Project	IEEE 802.16 Broadband Wireless Access Working Group	
Title	Proposed Revision to Section B.3 (SC PHY Link Budget Analysis)	
Date Submitted	2002-01-18	
Source(s)	Anader Benyamin-Seeyar Harris Corporation Inc. 3 Hotel de Ville Dollard-des-Ormeaux, Quebec, Canada, H9B 3G4	Voice: (514) 845-8850 Fax: (514) 871-4859 mailto: abenyami@harris.com
Re:	Proposal to revise Section B.3 of document IEEE P802.16a/D1-2001 with provided text.	
Abstract	The Link budget given in Tables 265 and 266 are being revised in Section B.3 of document IEEE P802.16a/D1-2001. This contribution simplifies and provides more accurate and comprehensive link budget results.	
Purpose	Incorporate provided text as revision of Section B.3 of document IEEE P802.16a/D1-2001.	
Notice	This document has been prepared to assist IEEE 802.16. It is offered as a basis for discussion and is not binding on the contributing individual(s) or organization(s). The material in this document is subject to change in form and content after further study. The contributor(s) reserve(s) the right to add, amend or withdraw material contained herein.

Revision of SC PHY Link Budget Analysis

B.3: SC PHY LINK Budget Analysis

Figure 248a Path Loss Model for 30 m Base Station antenna height (for Category C).

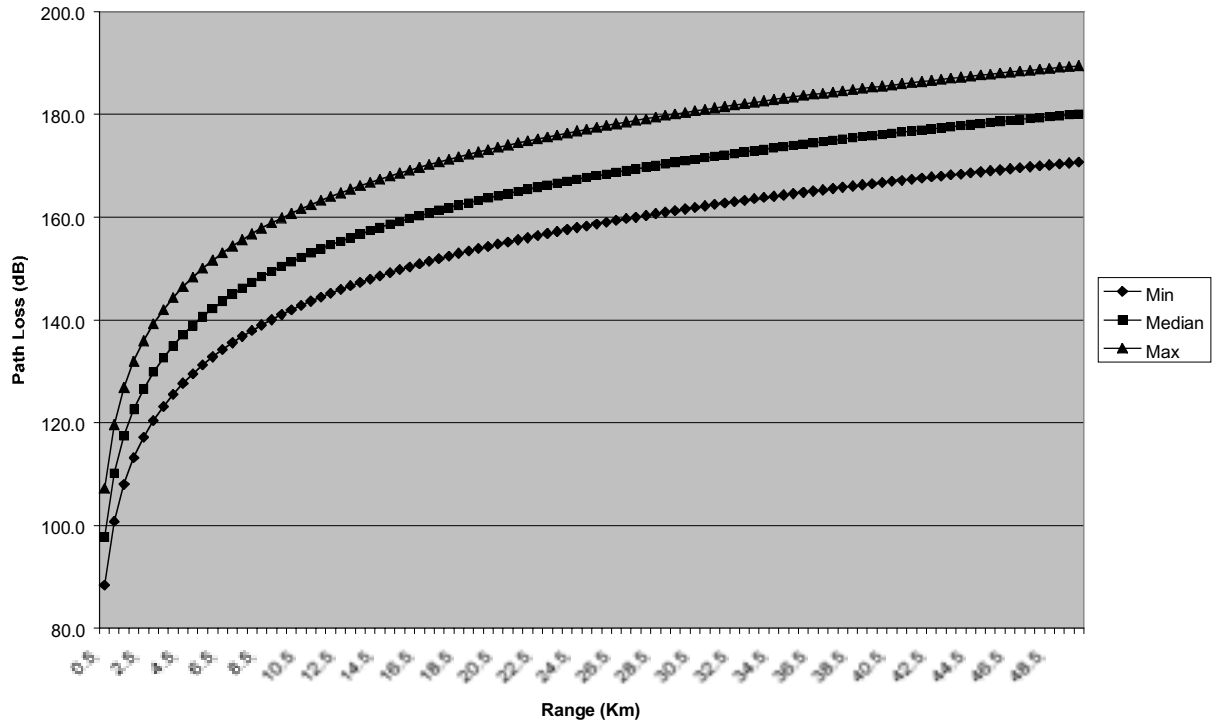
A complete link budget analysis was performed by combining various channel bandwidths and QAM constellations with the channel models found in [B64]. Two examples of the path loss versus propagation radius for Category C of the propagation model in [B64], assuming a 30 m and 80 m BS antenna and 6.5 m SS antenna, are shown in Figures 248a and 248b for **3.5 GHz** band.
